Duquesne Light

SUBJECT: 10CFR50.55(f)(1) SAR QA Program

DUQUESNE LIGHT COMPANY CHANGES

FIGURE 17.1 - 1A
DUQUESNE LIGHT COMPANY
ORGANIZATION FOR QUALITY ASSURANCE
BEAVER VALLEY POWER STATION - UNIT 2
PRELIMINARY SAFETY ANALYSIS REPORT

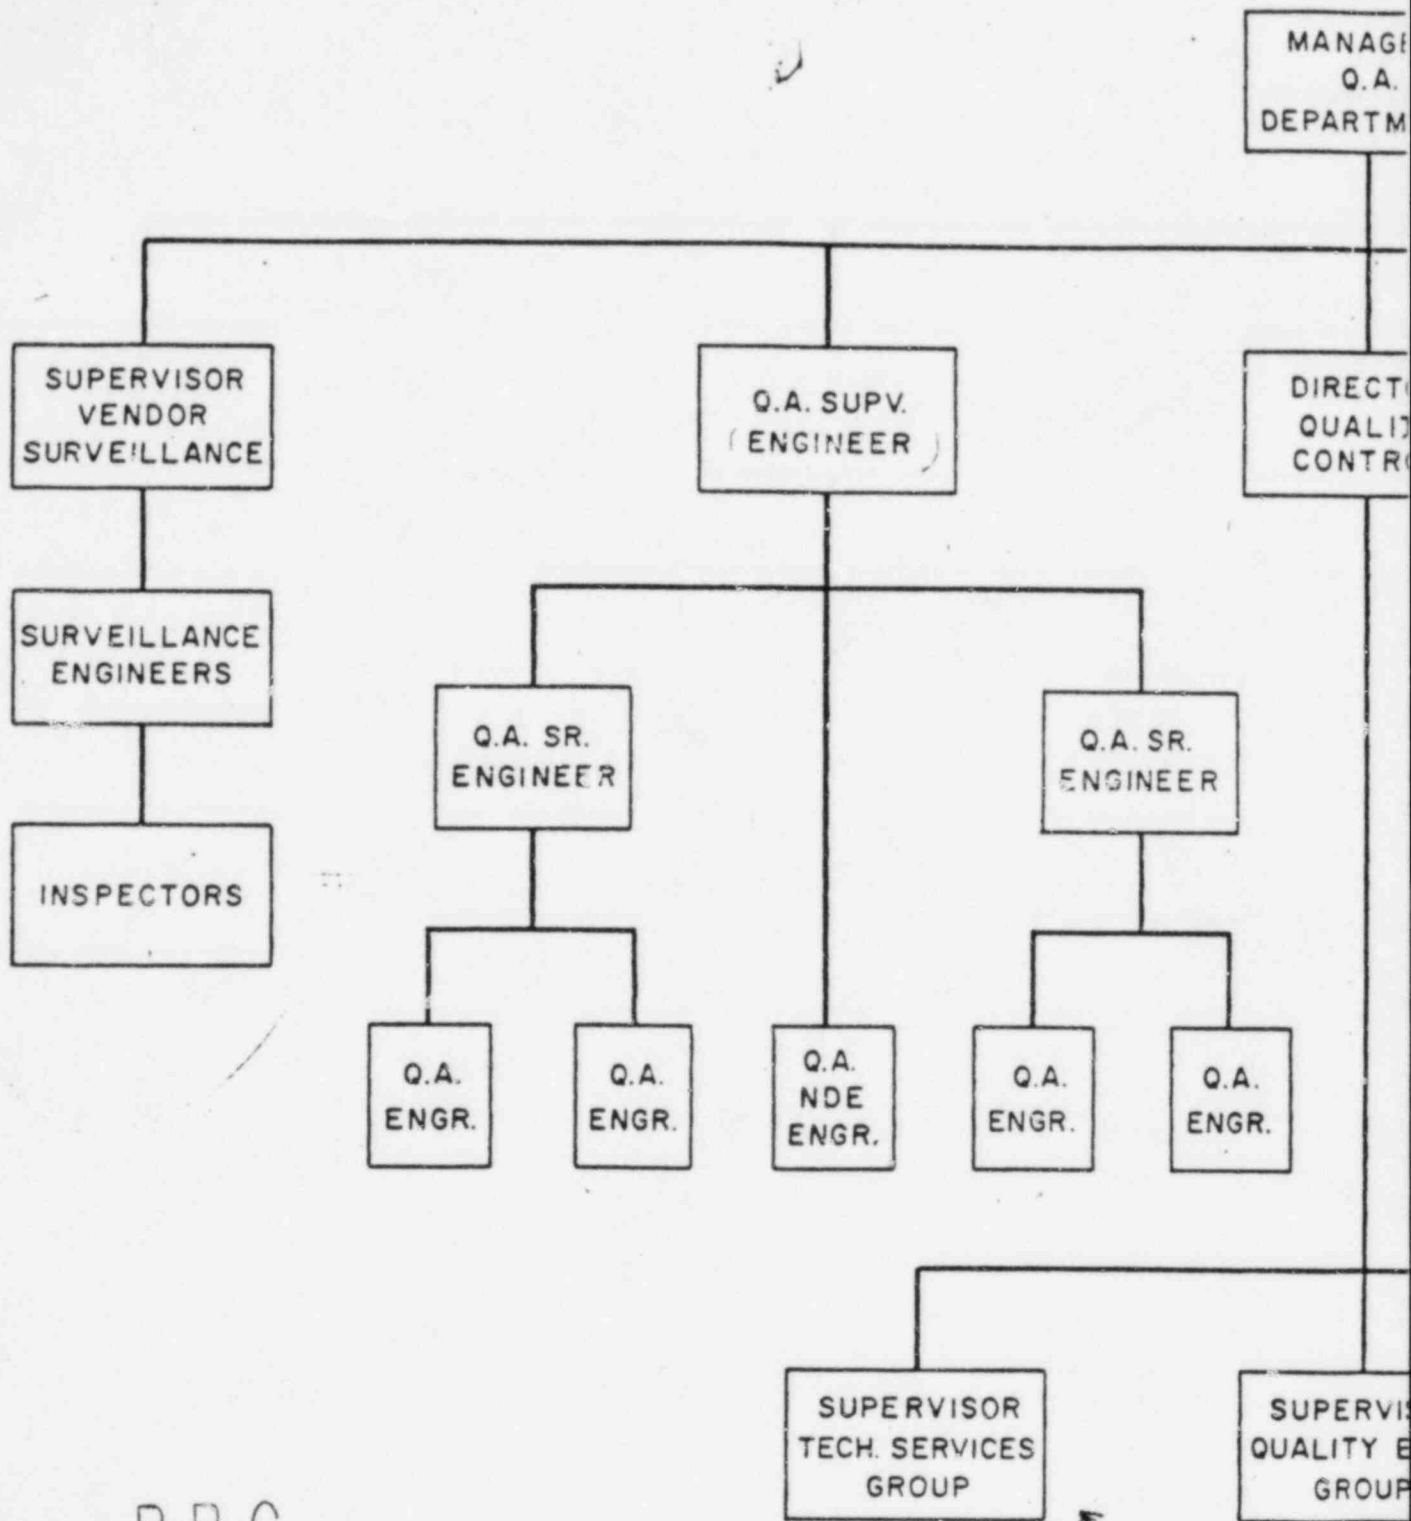
7. As shown on the organization chart in Attachment 1, the structure is different from the one described. The responsibilities stated have been reassigned but not deleted. Fundamentally, the organization is stronger with the creation of the Nuclear Construction Division.

FIGURE 17.1-3A

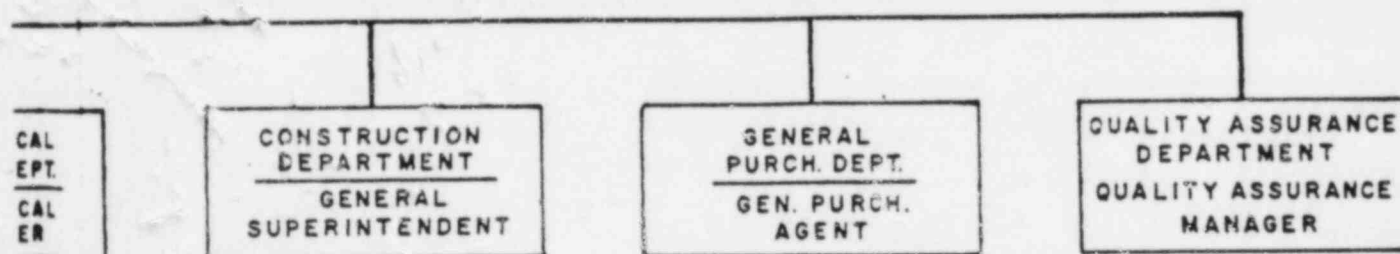
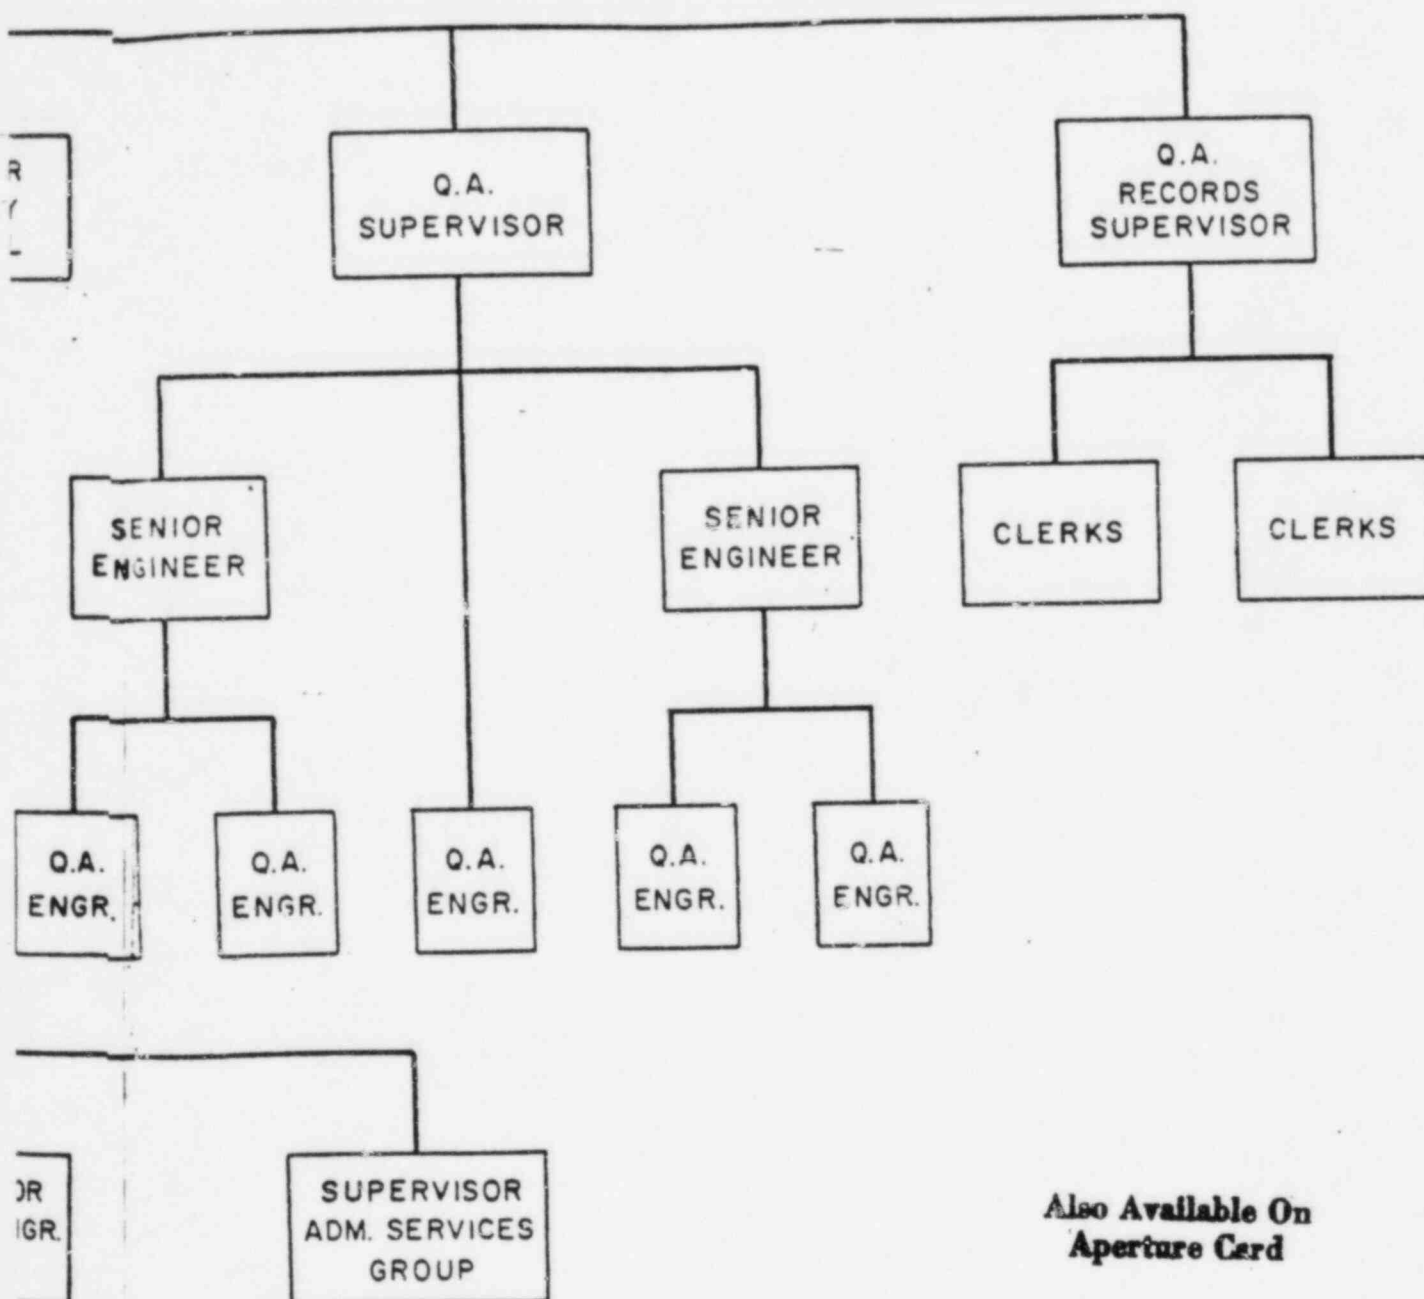
6. These two groups are now contained within the recently organized Nuclear Construction Division (Attachment 2). The Project Manager is in charge of the Manager of Administrative Services, Regulatory Affairs, Engineering, and Construction. The QA Manager reports directly to the NCD Vice President. Meetings are now held monthly rather than bimonthly.

Figure 1
1-5
Revision E

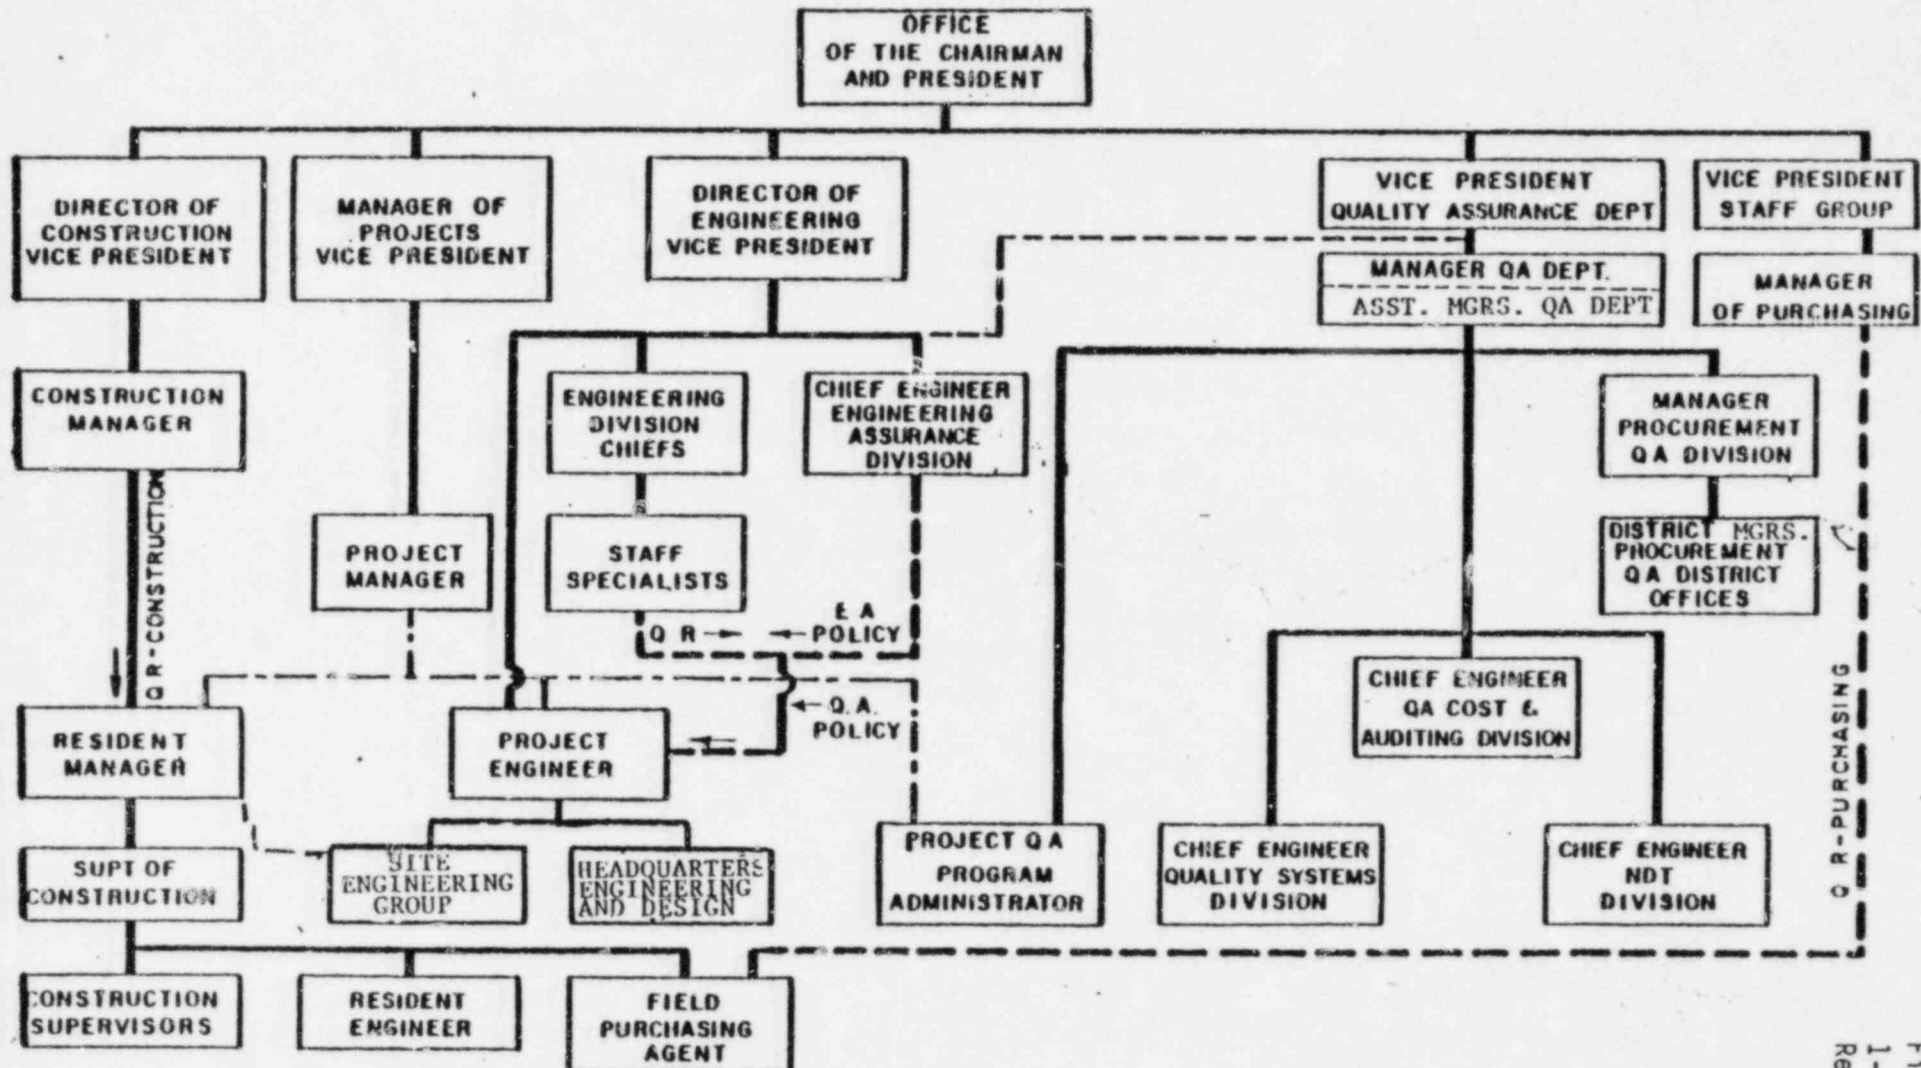
Current SWEC organizational charts are provided in the text.
